Title: ZX Interface 1 New Layout SMD PLCC Narrow

Size: A4	Date: 2026−10−28	**Rev: 2.0**
KiCad E.D.A. 10.0.6		Id: 1/3

Sheet: /
File: ZX Interface 1 New Layout SMD PLCC Narrow.kicad_sch

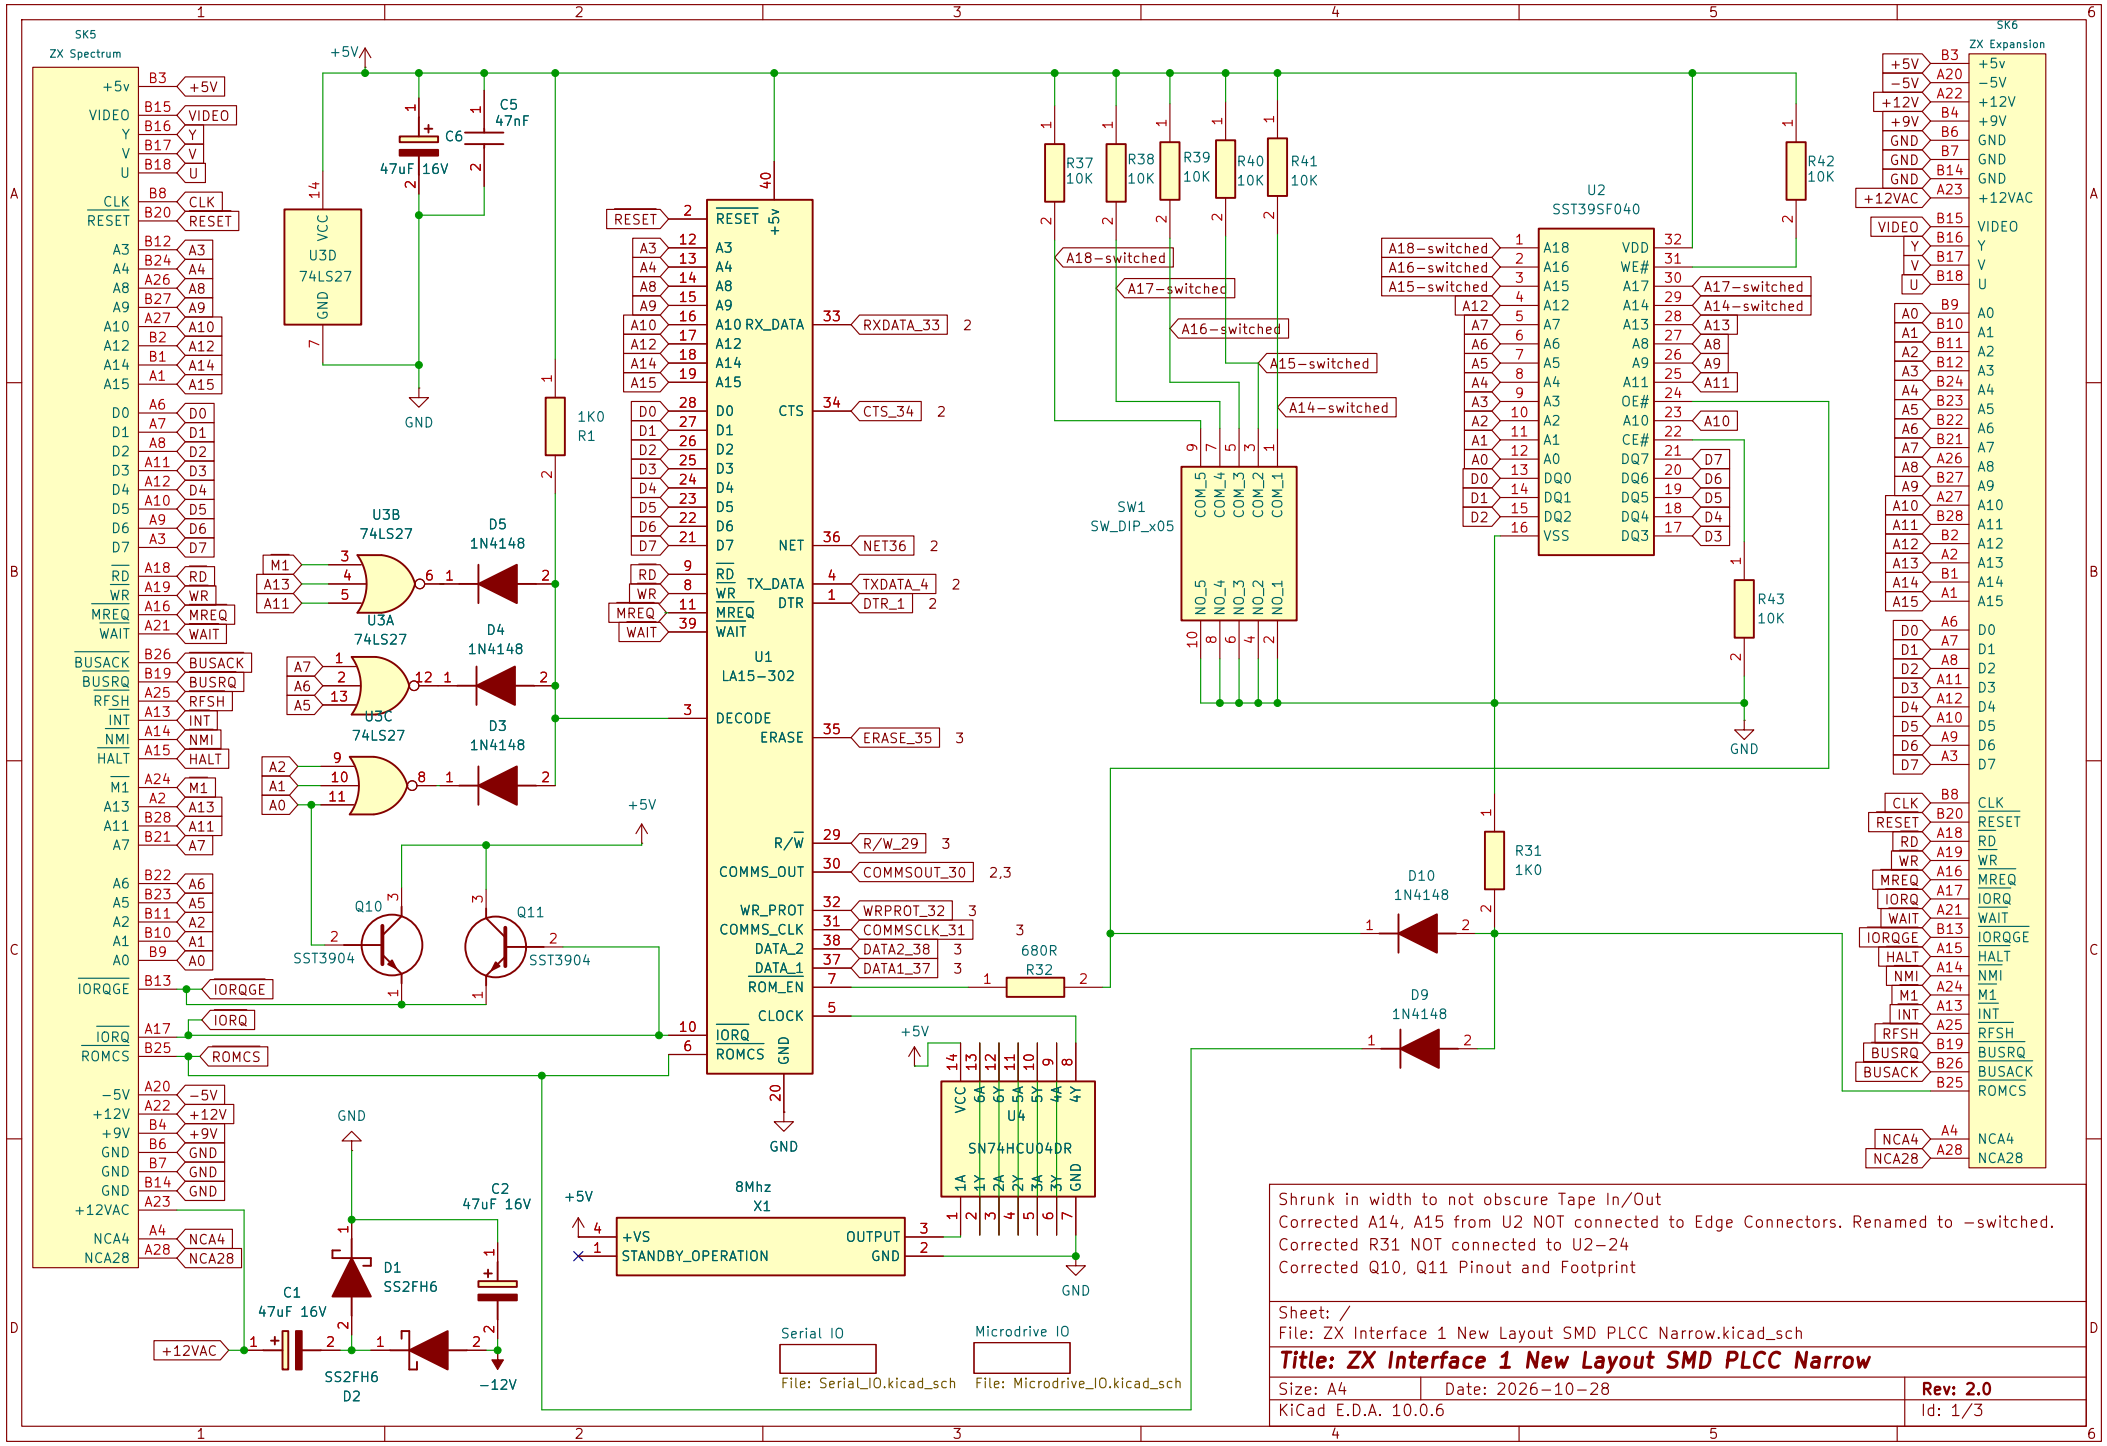
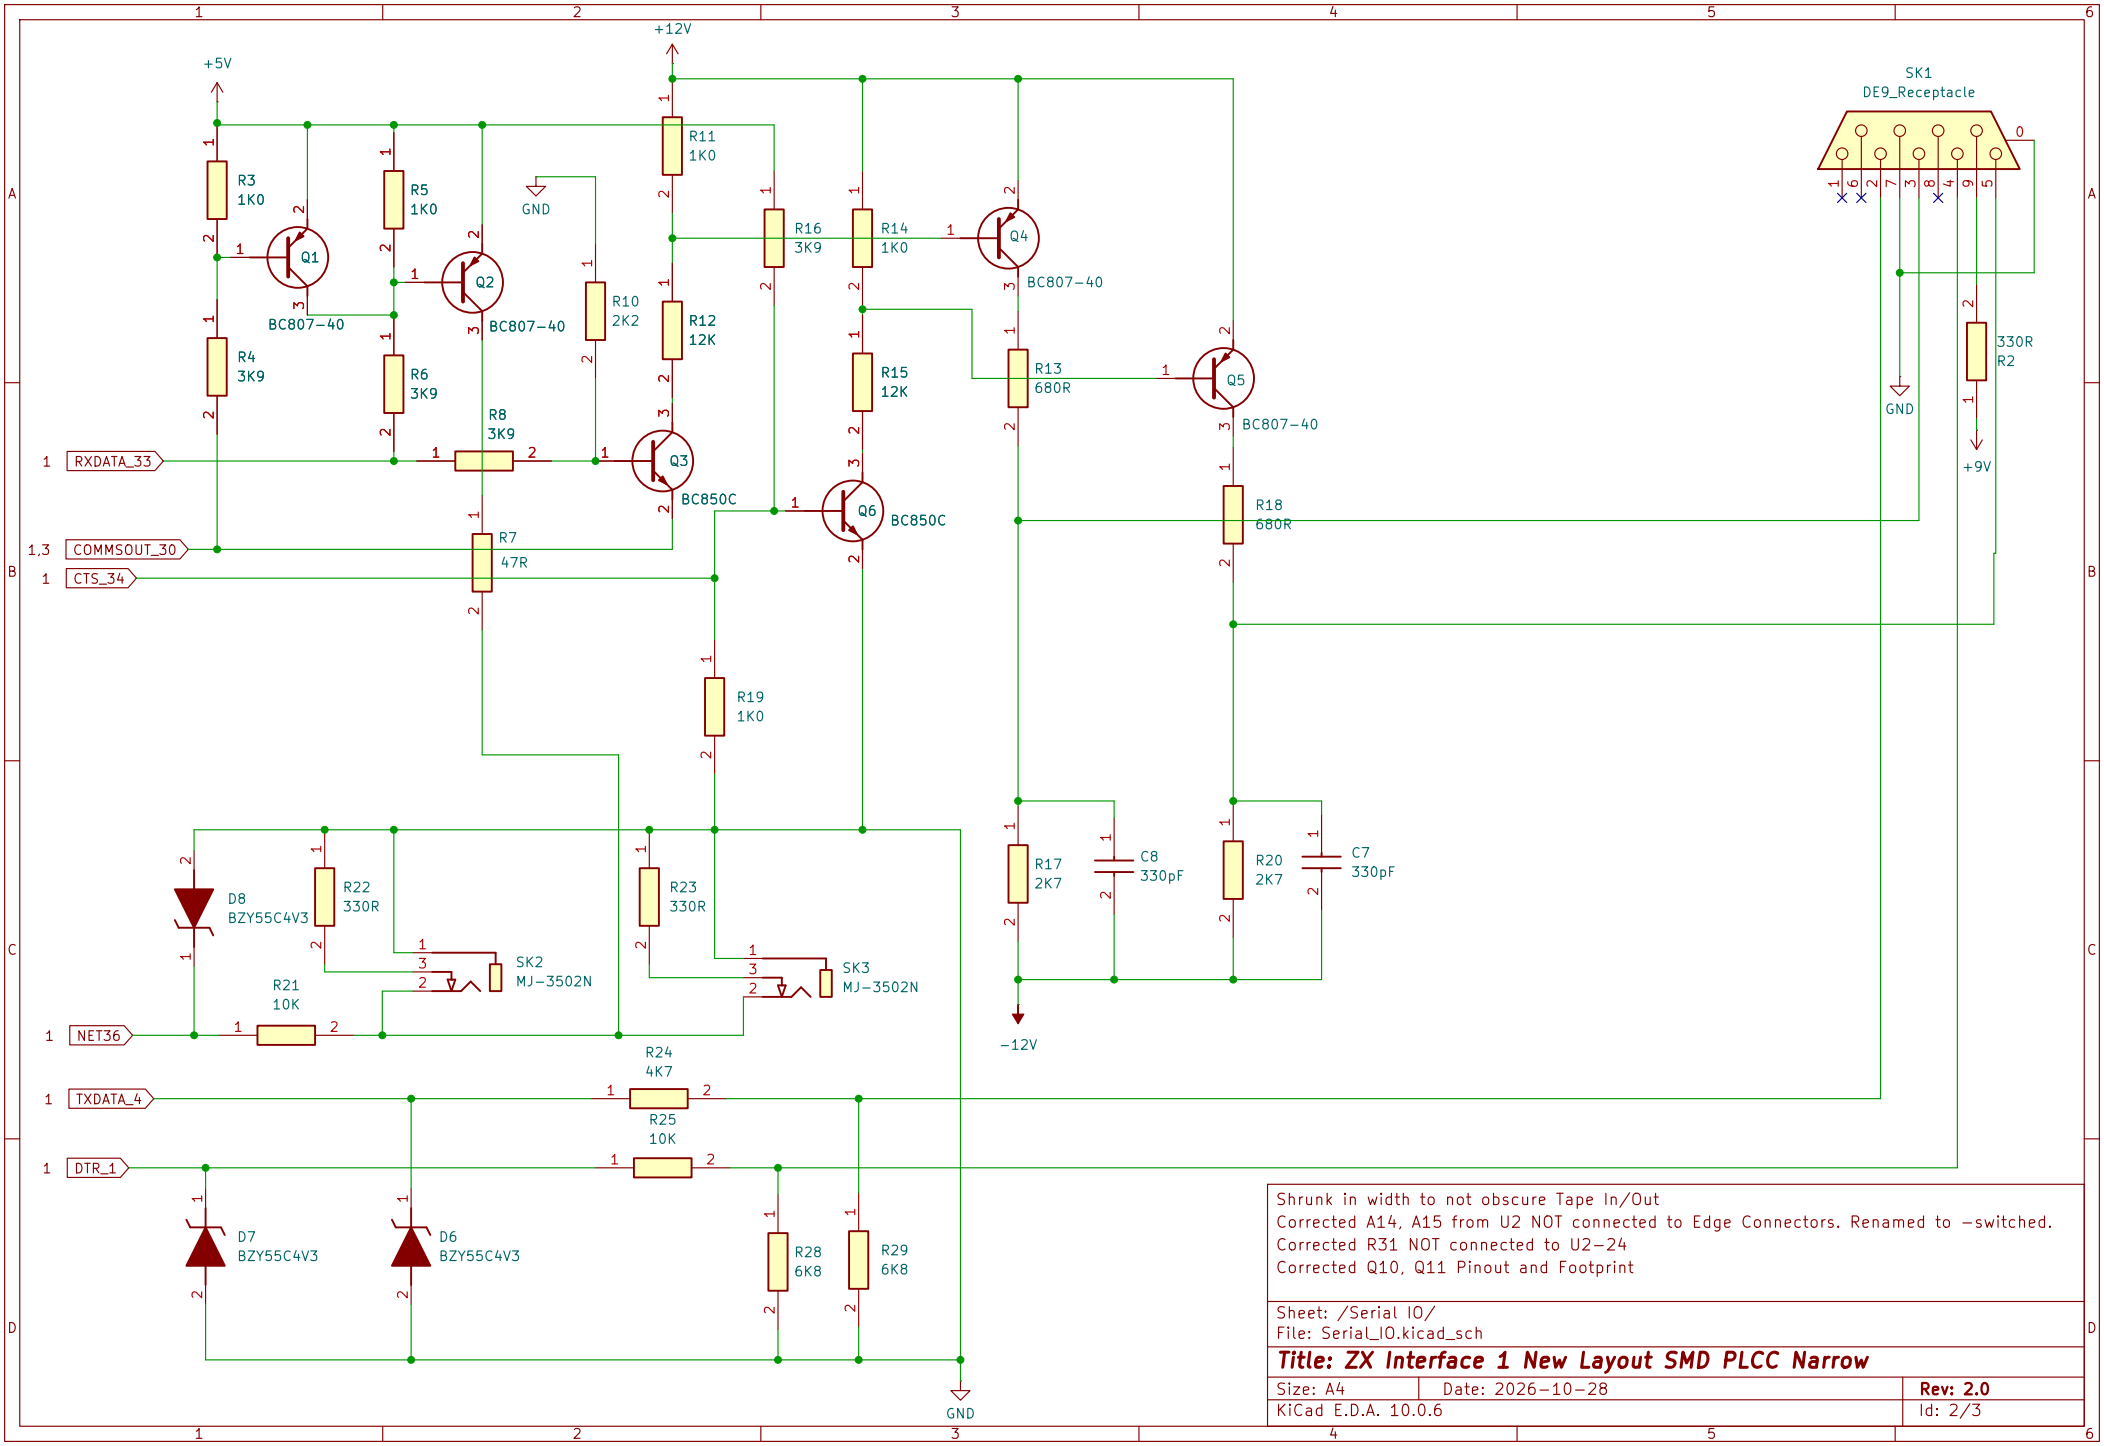
Shrunk in width to not obscure Tape In/Out
Corrected A14, A15 from U2 NOT connected to Edge Connectors. Renamed to −switched.
Corrected R31 NOT connected to U2−24
Corrected Q10, Q11 Pinout and Footprint

Sheet: /Serial IO/
File: Serial_IO.kicad_sch

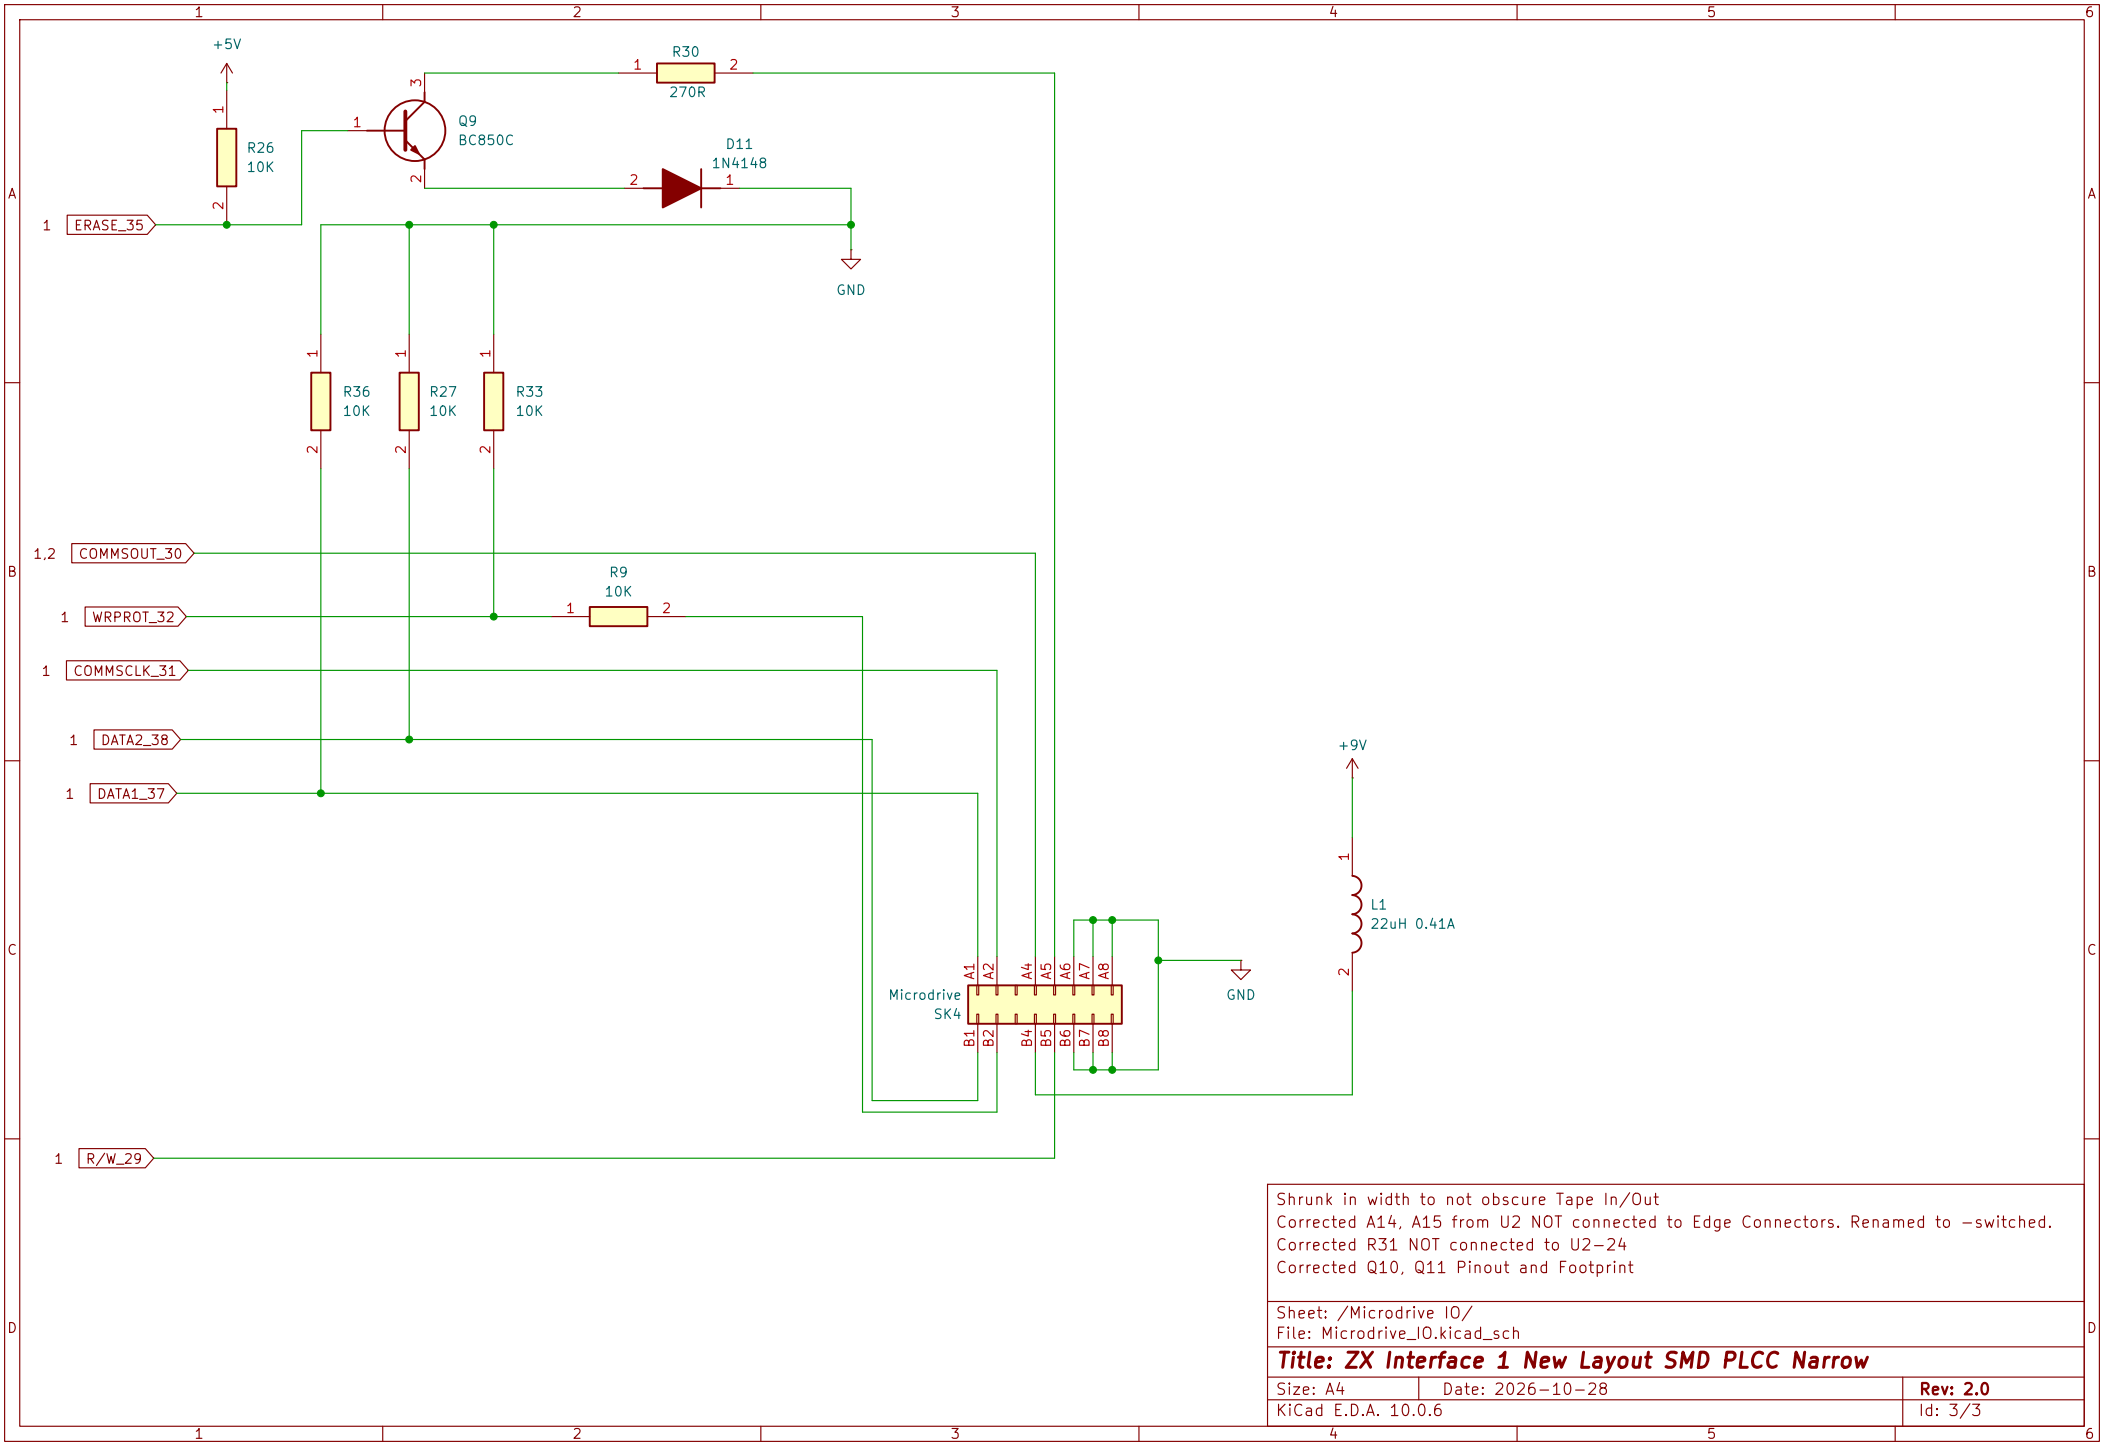
Shrunk in width to not obscure Tape In/Out
Corrected A14, A15 from U2 NOT connected to Edge Connectors. Renamed to -switched.
Corrected R31 NOT connected to U2-24
Corrected Q10, Q11 Pinout and Footprint
